Residential Development at
Little Pakyns, Albourne Road, Hurstpierpoint.

PART-RETROSPECTIVE APPLICATION FOR ALTERATIONS TO APPROVAL REF DM/23/2031

SUPPORTING STATEMENT

As currently built South Elevation
N.B. project still under construction, yet to be completed.

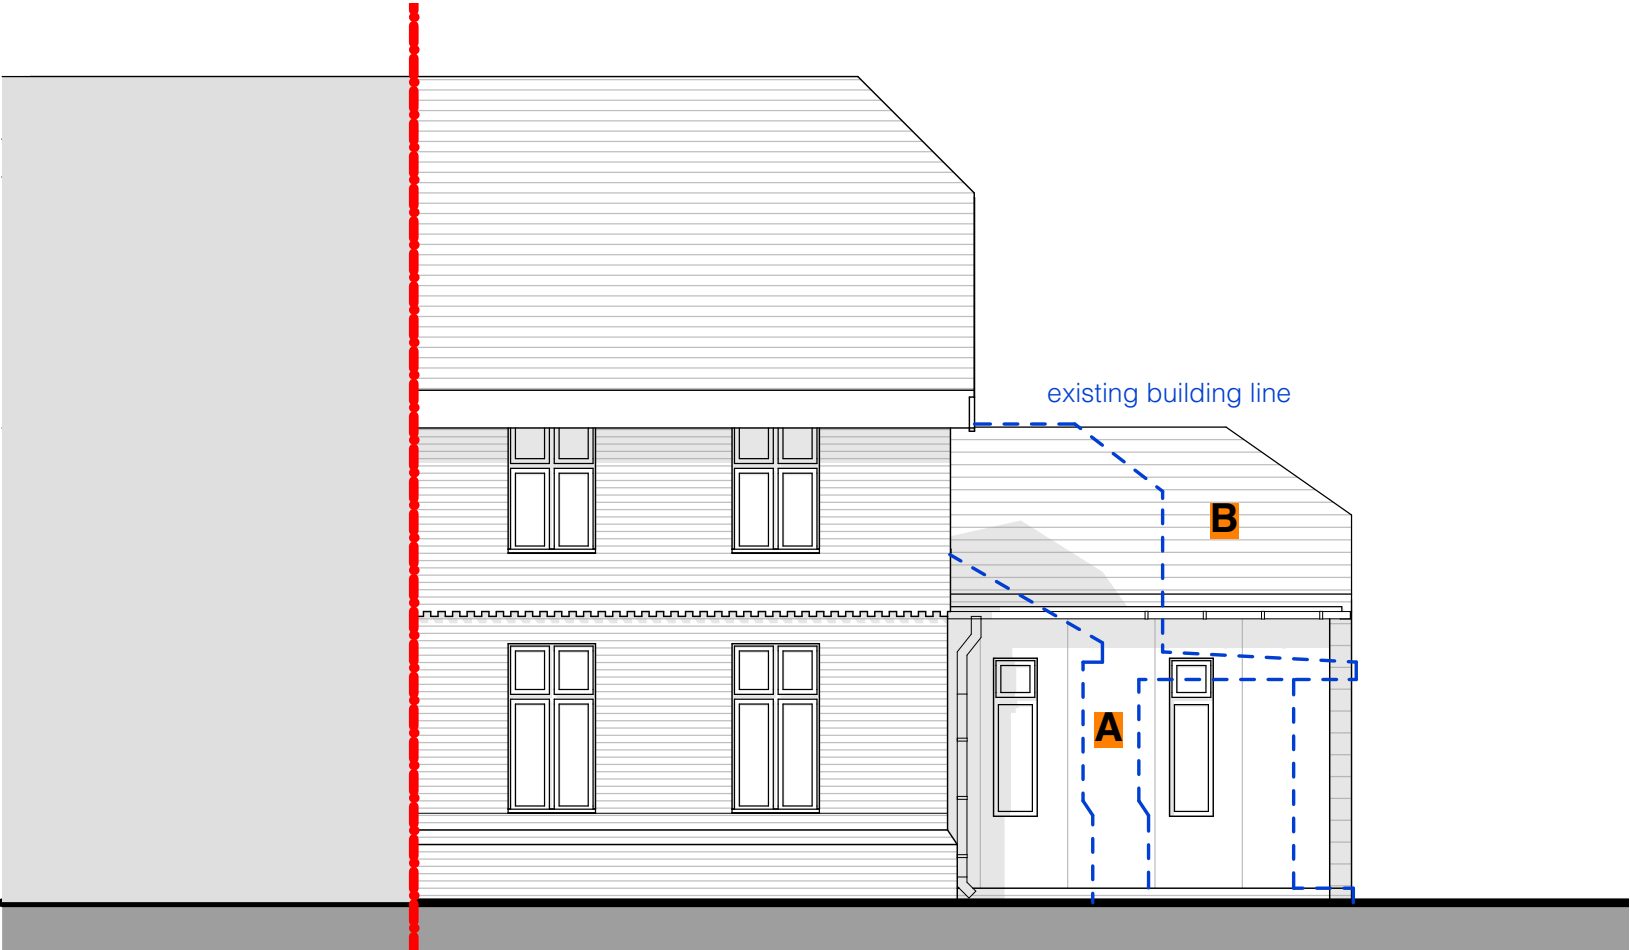
“As we noted on site the windows to the side elevation of the flat roofed element of the extension are not in accordance with the approved design. As we discussed during our site meeting, unfortunately the windows as installed are not sympathetic to the context. During a recent telephone conversation the property owner indicated that they would be willing to simply block up the window openings, however as this would result in an unrelieved, blank elevation I do not consider that this is an appropriate solution to the problem. In my opinion, the best option will be to alter the openings to match the approved design.”

The windows to the southern elevation are proposed to be amended to reflect those on the adjoining property's southern elevation.

This proposal was sent to Emily Wade via email for informal comment prior to submission of this application and she confirmed “...in my opinion the revised window design shown is likely to be acceptable” (email reply dated 21st July 2025).

Proposed external materials
N.B. project still under construction, yet to be completed.

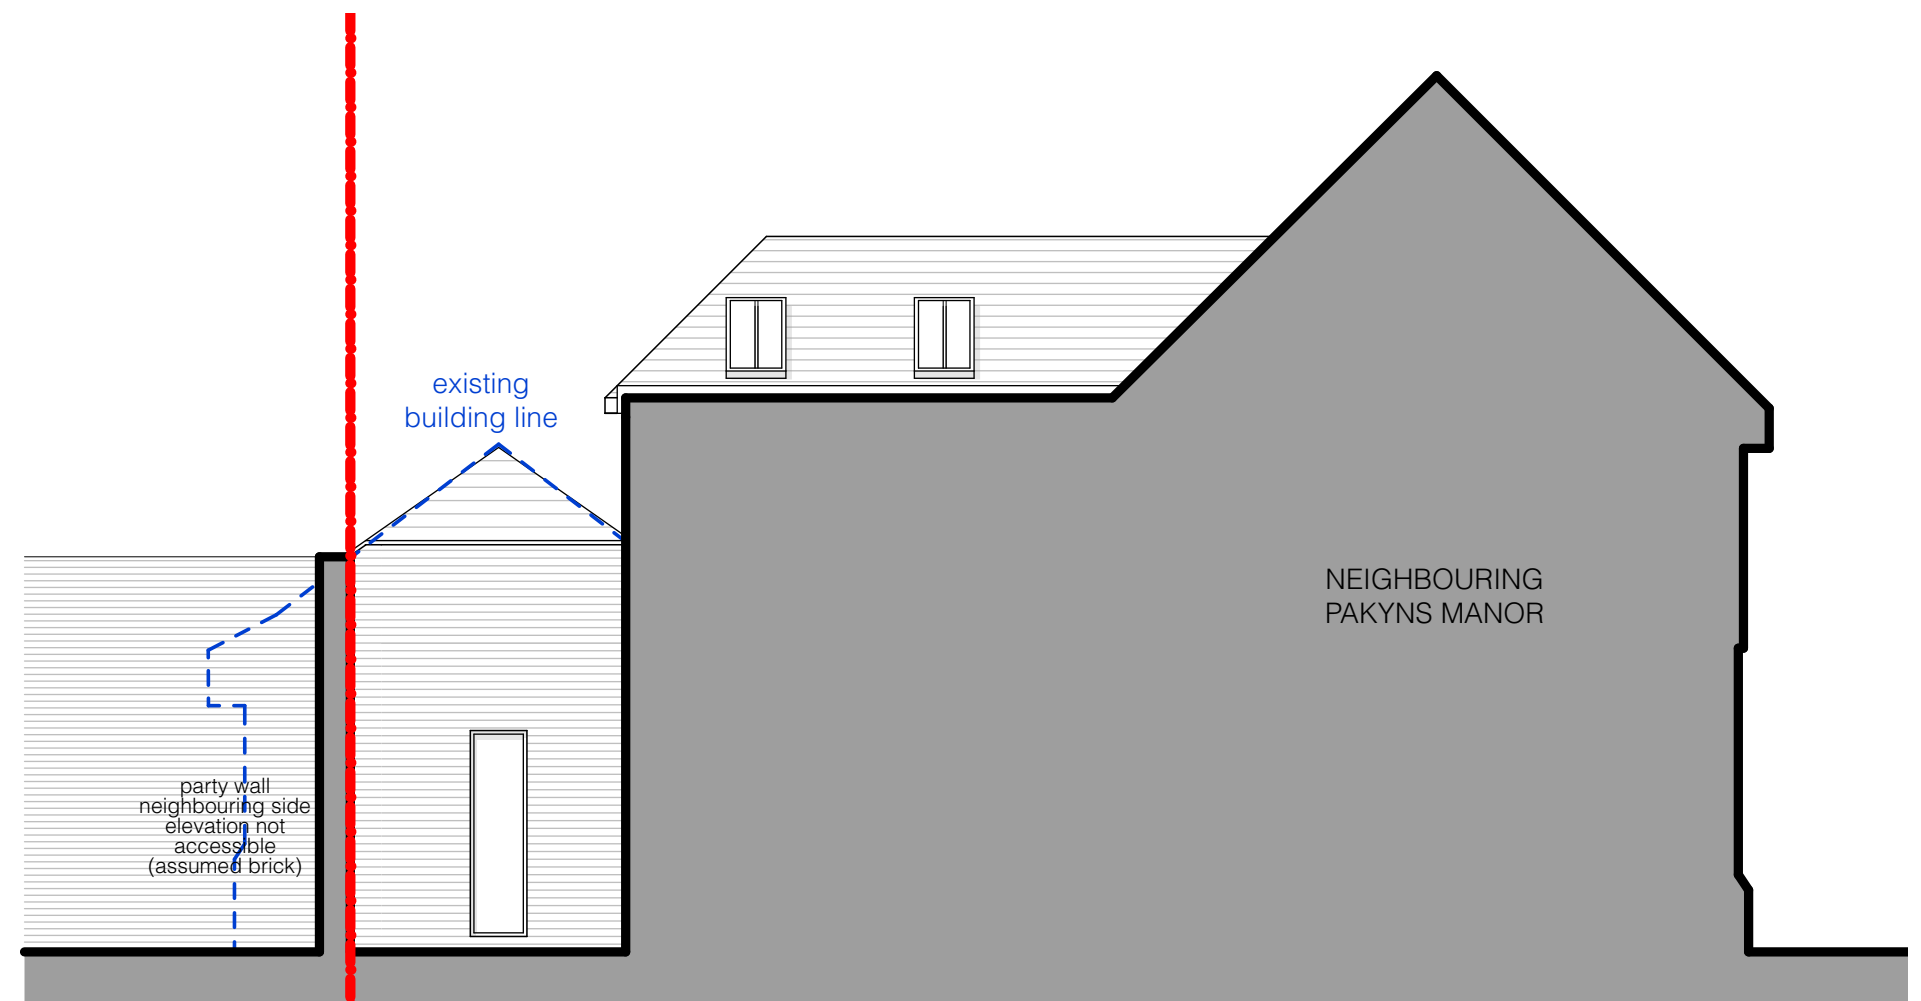
“The applicant has indicated to me that they intend to go ahead with the approved facing material to the flat roofed element of the extension, which is of course acceptable. With respect to the tiling to the gabled element, which is unacceptable as installed, it is my understanding that the applicant is still in discussions with the supplier to resolve the situation. We would expect the finished scheme to closely reflect the clean, contemporary lines shown on the approved drawings, including the profile of both the hung and roof tiles, and the ridge detailing. I would expect the applicant to provide further details of how this is to be resolved in due course.”

The proposed facing materials are to be as approved under the Approval of Conditions application. The building is yet to be completed therefore these have not been completed yet.
